PUR-1751
ADDENDUM NO. 1
INVITATION TO BID

HAGERSTOWN REGIONAL AIRPORT
EXPAND/REHABILITATE TERMINAL BUILDING EAST

DATE: Thursday, June 12, 2025

C2.0

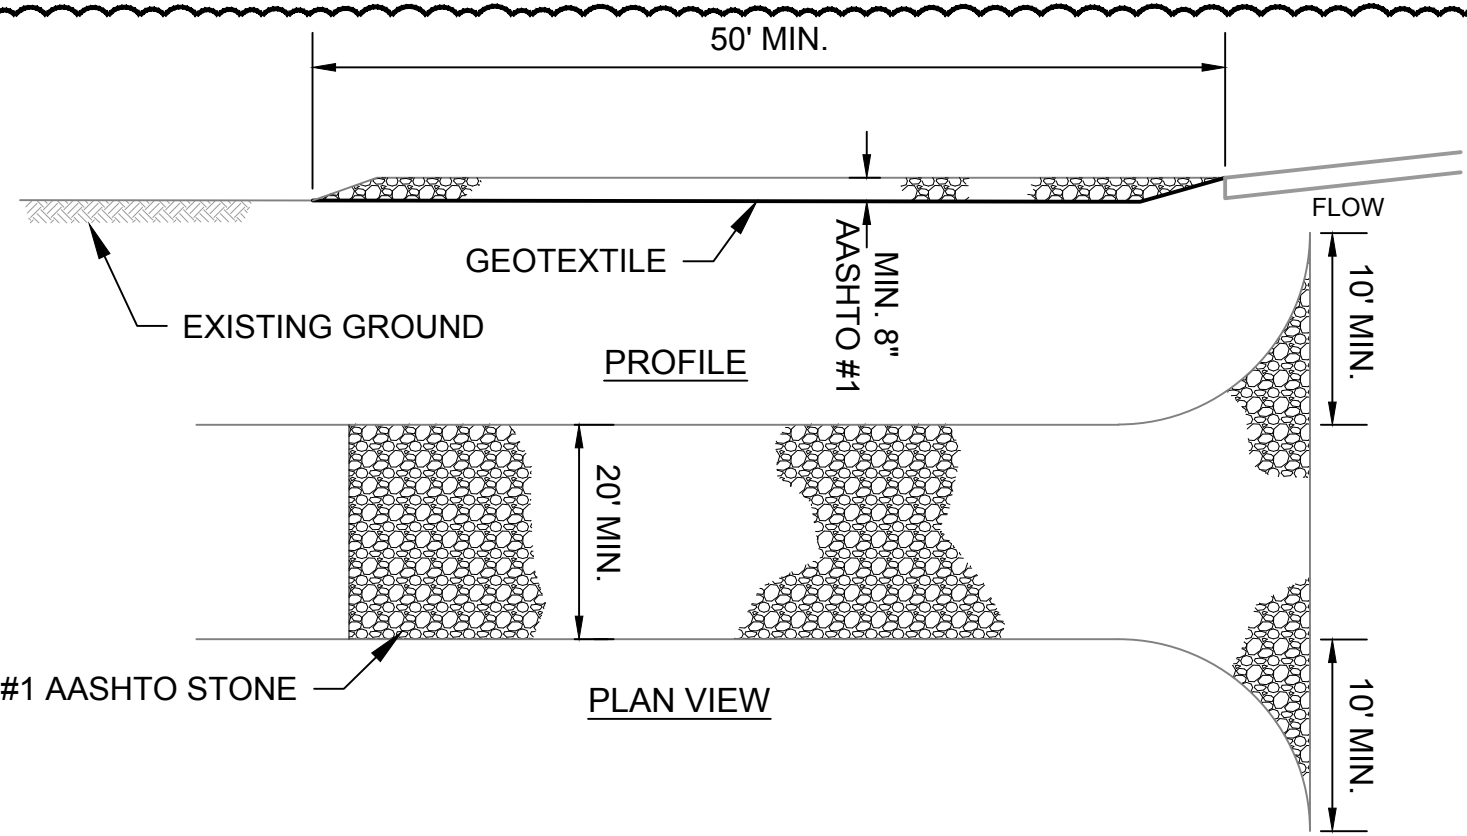
ITEM NO. 20: Sheet No. C2.0 Erosion and Sediment Control Plan:

REVISE: Sheet title to read:

EROSION AND SEDIMENT CONTROL PLAN

REVISE: Proposed legend to include Inlet Protection symbol

REVISE: Proposed fence line type for consistency with other plan sheets.

FAA ATP No.: 3-24-0019-XX-2025
Bid No.: PUR-1751
MAA Grant No.: MAA-GR-XX-XXX
SUBMISSION: BID SET
SHEET No.: C2.1
15 OF 102

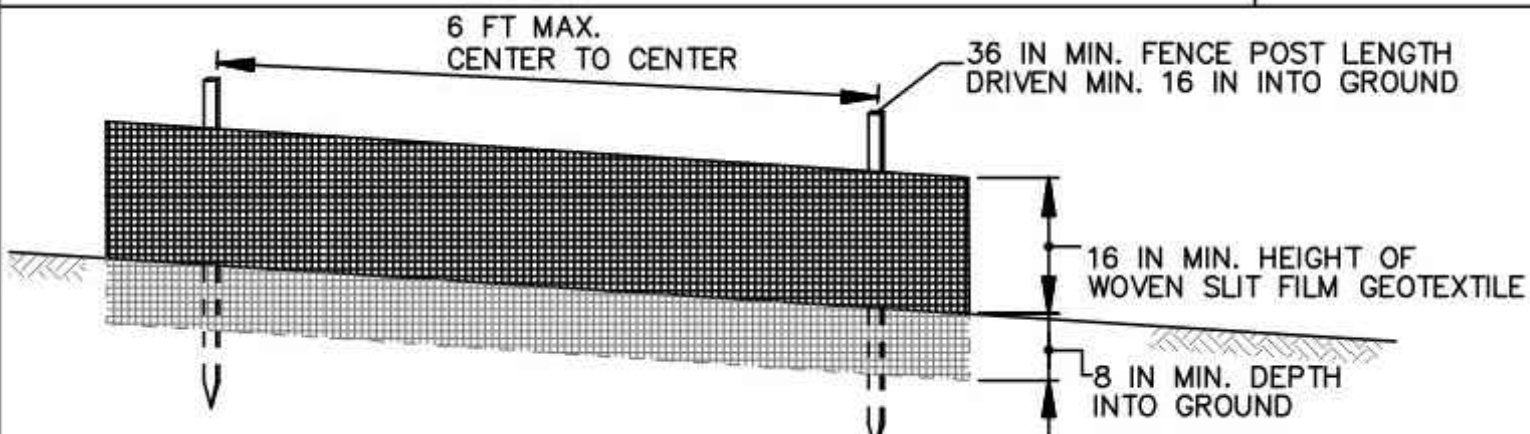
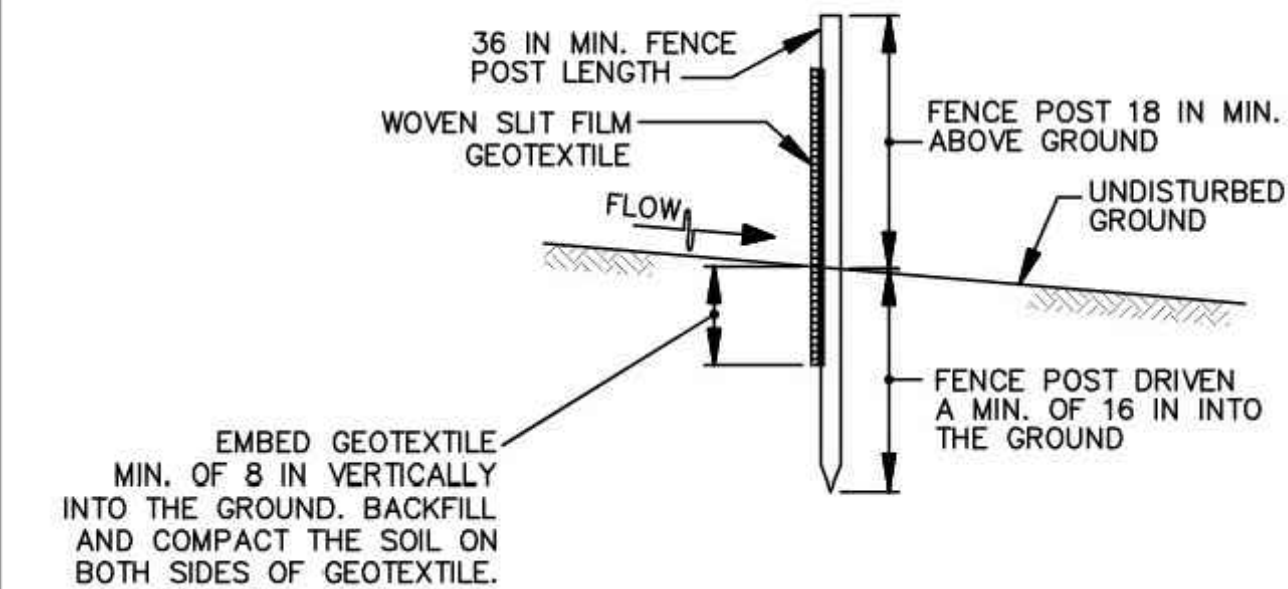
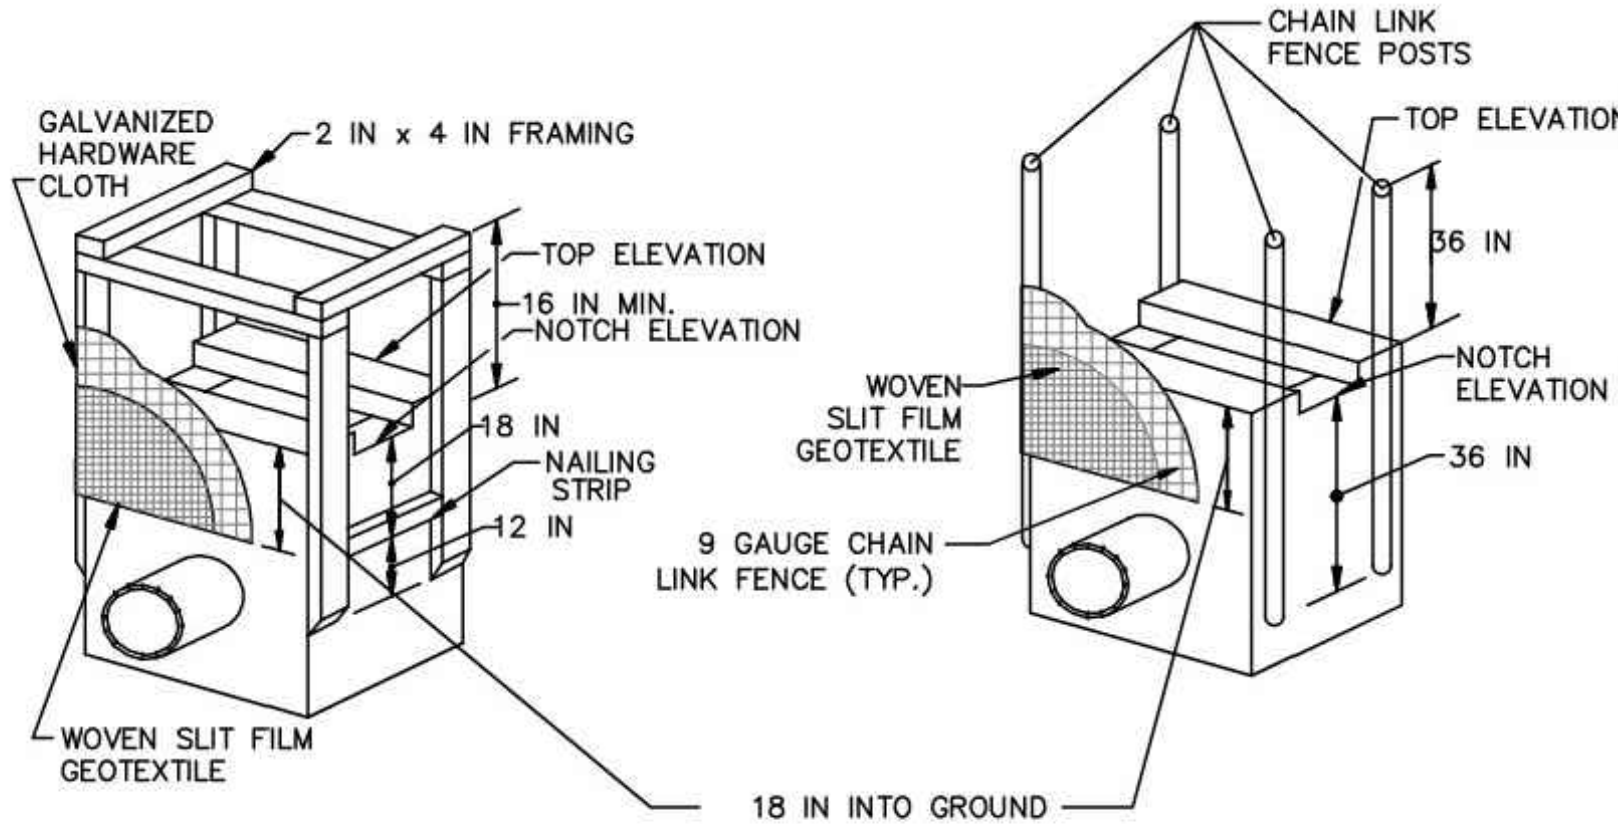
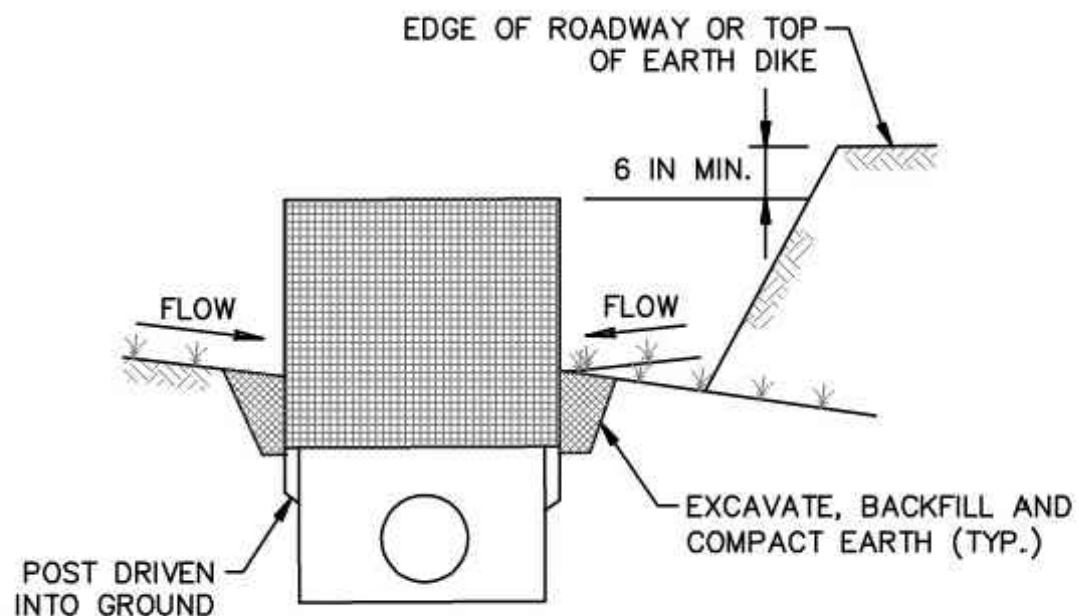
ITEM NO. 21: Sheet No. C2.1 Erosion and Sediment Control Notes and Details:

ADD: the following details to the sheet:

ROCK CONSTRUCTION ENTRANCE

SILT FENCE

STANDARD INLET PROTECTION

STORMWATER MANAGEMENT PLAN

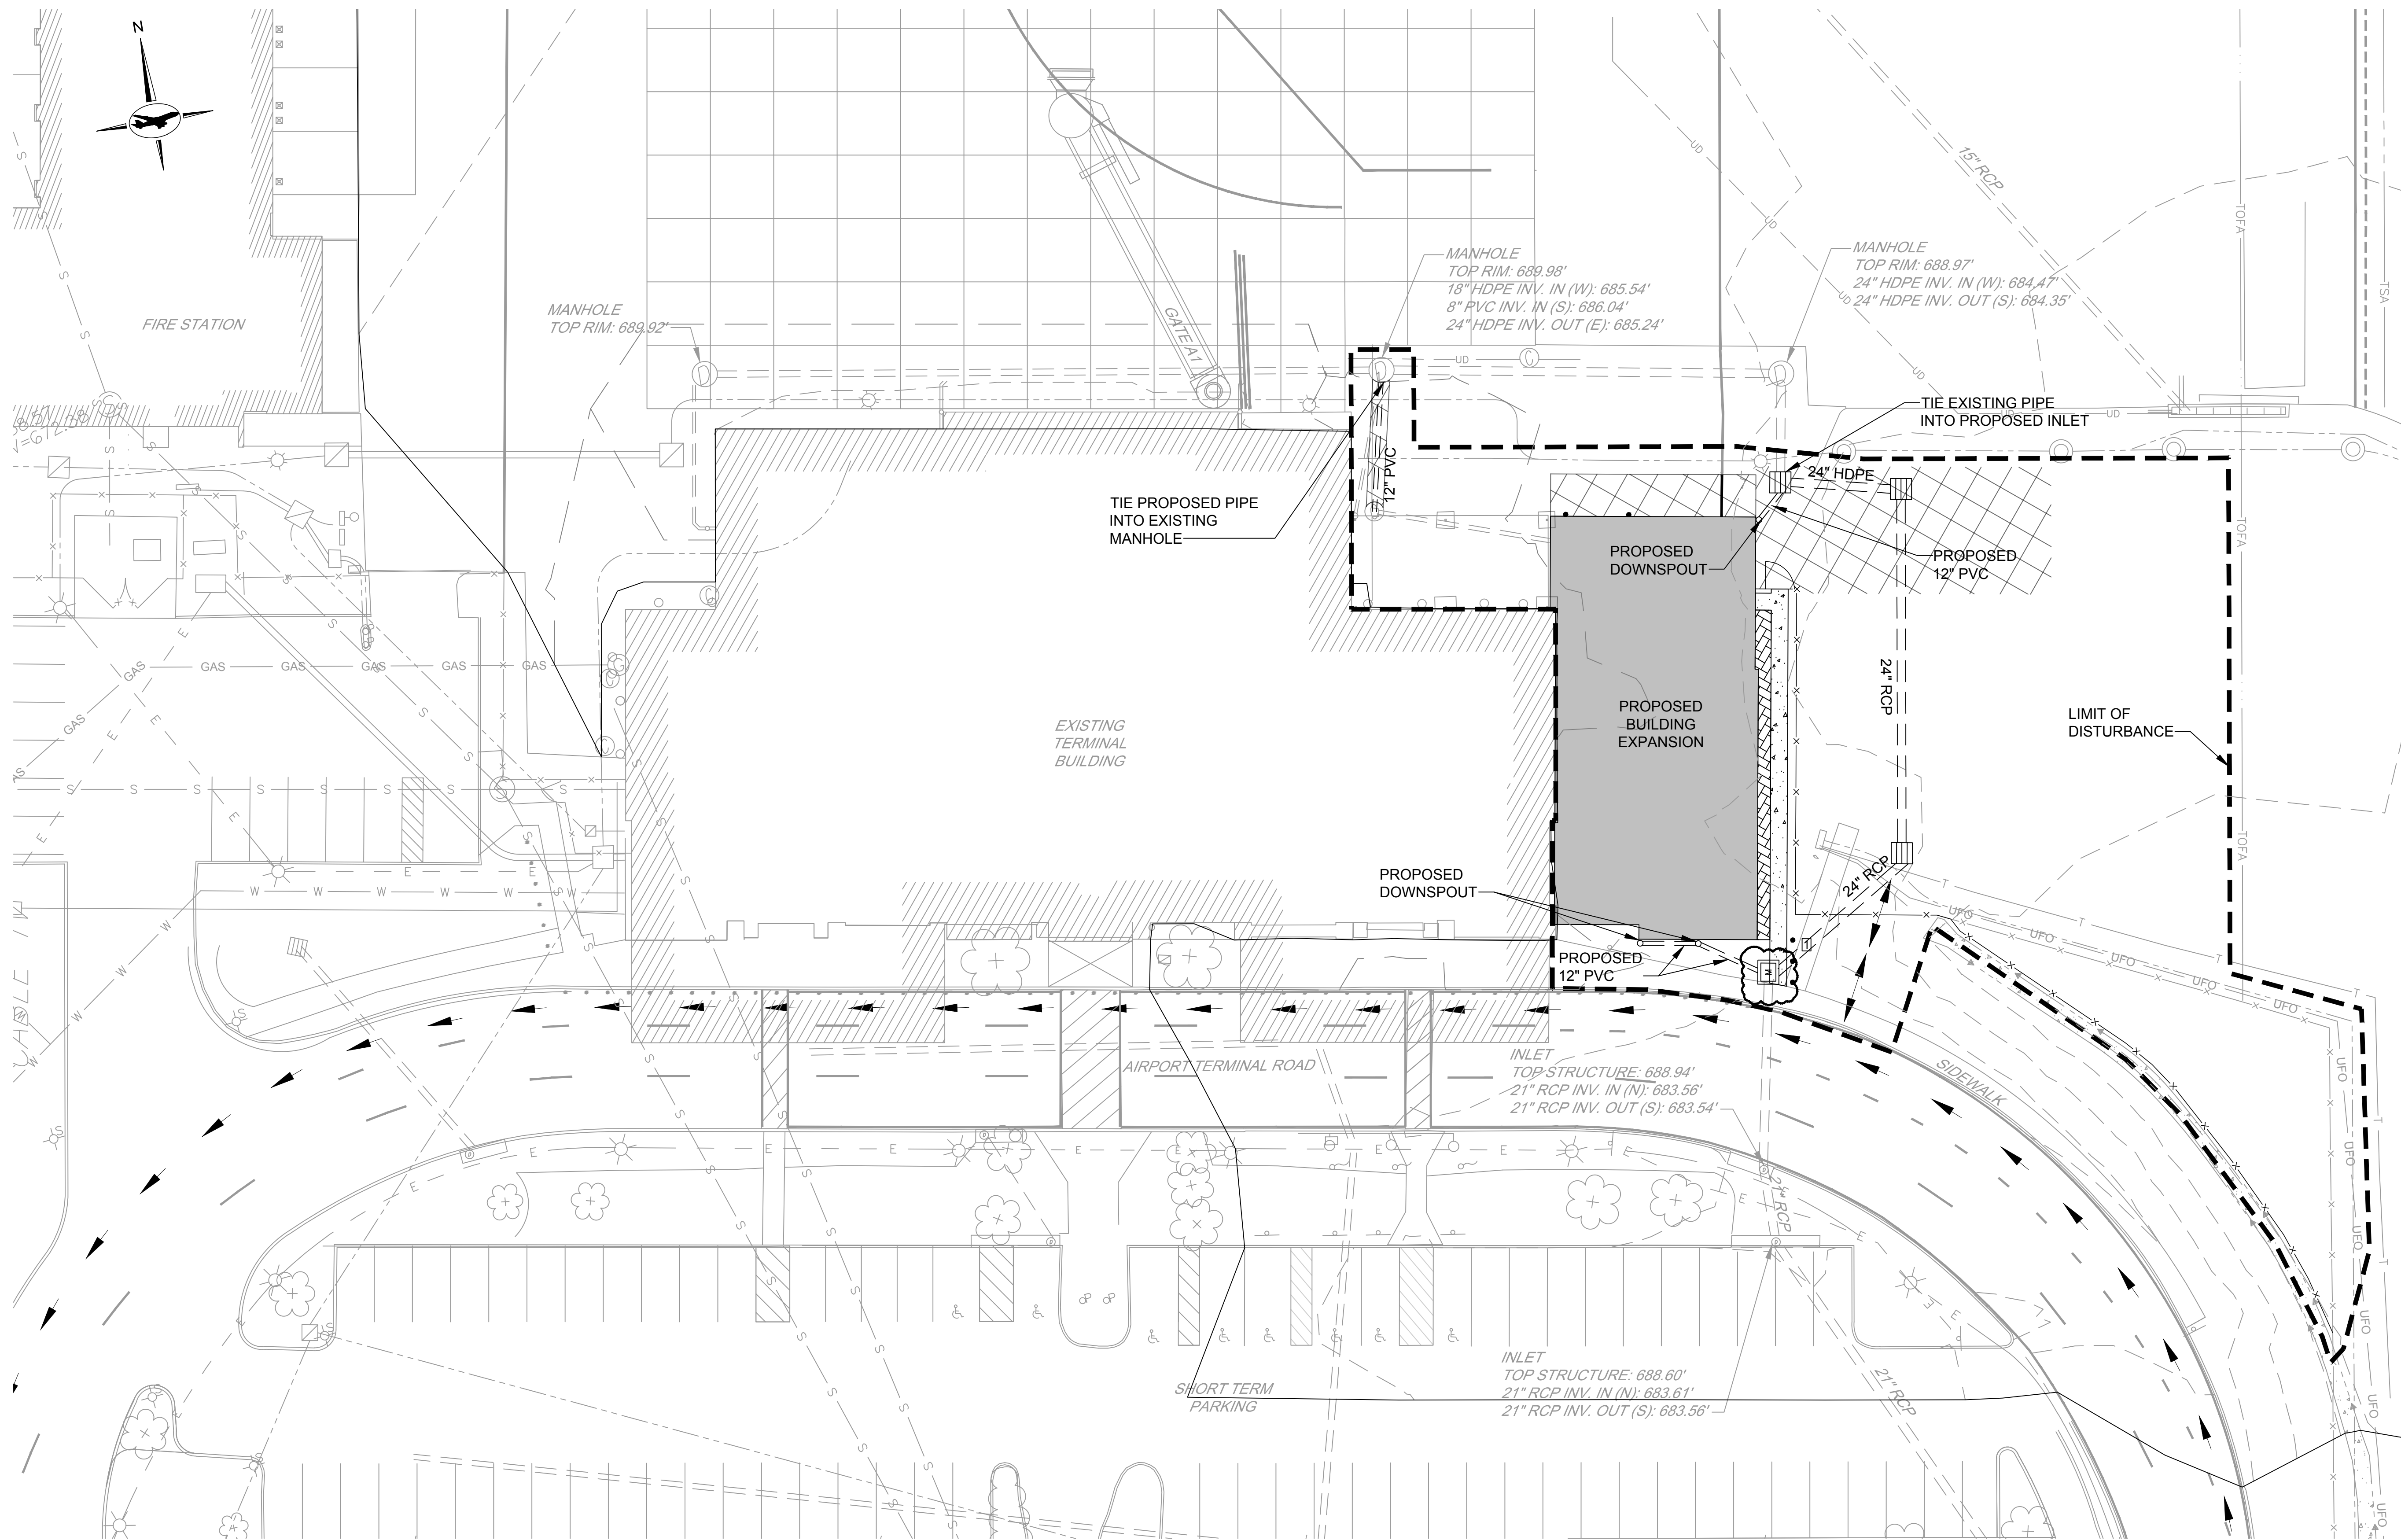
ITEM NO. 22: Sheet No. C3.0 Stormwater Management Plan:

REVISE: Identification of the proposed manhole and add symbol to proposed legend.

REVISE: Proposed fence line type for consistency with other plan sheets.
